Request for Quotation

RFQ NUMBER
 GSD106402

LINE	QUANTITY	UOP	CAT NO	ITEM NUMBER	UNIT PRICE	AMOUNT
ADDENDUM NO. 2						
THIS ADDENDUM IS ISSUED TO:						
1.) PROVIDE A COPY OF THE MANDATORY PRE-BID ATTENDEE LIST,						
2.) ANSWER ALL TECHNICAL QUESTIONS SUBMITTED PRIOR TO THE DEADLINE FOR TECHNICAL QUESTIONS.						
3.) PROVIDE THE ATTACHED DOCUMENTS SECTION 08110: METAL DOORS AND FRAMES						
4.) PROVIDE THE ATTACHED REVISED DRAWINGS: DRAWING SK A-1 DRAWING SK A-2 DRAWING SK A-3 DRAWING SK A-4						
BID OPENING DATE REMAINS: 08/06/2009						
BID OPENING TIME REMAINS: 1:30 PM						
***** END ADDENDUM NO. 2 *****						
0001		LS		910-79		
	1					
BLDG#84 WINDOW REPLACEMENT

RFQ#GSD106402, Bldg#84 Window Replacement
Technical Questions and Answers

BUILDING 84
SOUTH ELEVATION

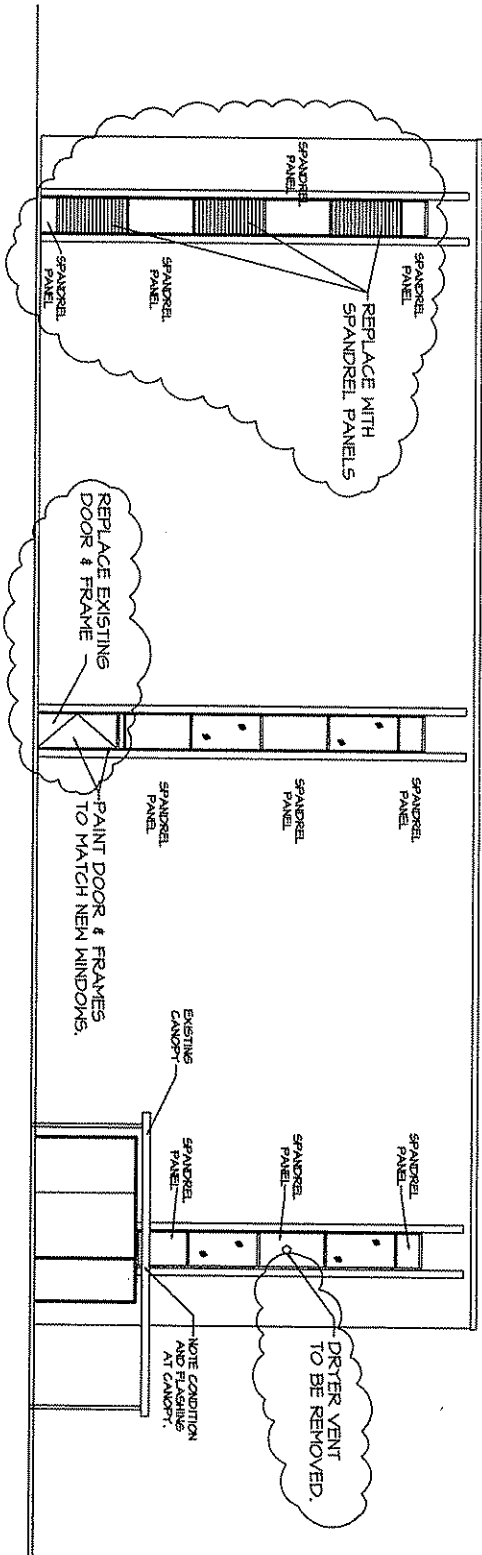
Question #5: Can the louver be changed to a glazable thinner louver rather than the 4" louver specified? Will email profiles.

Answer #5: Delete louvers . The window section with louvers is a blanked out window in the northwest corner stairwell. Replace entire window section with spandrel glass.
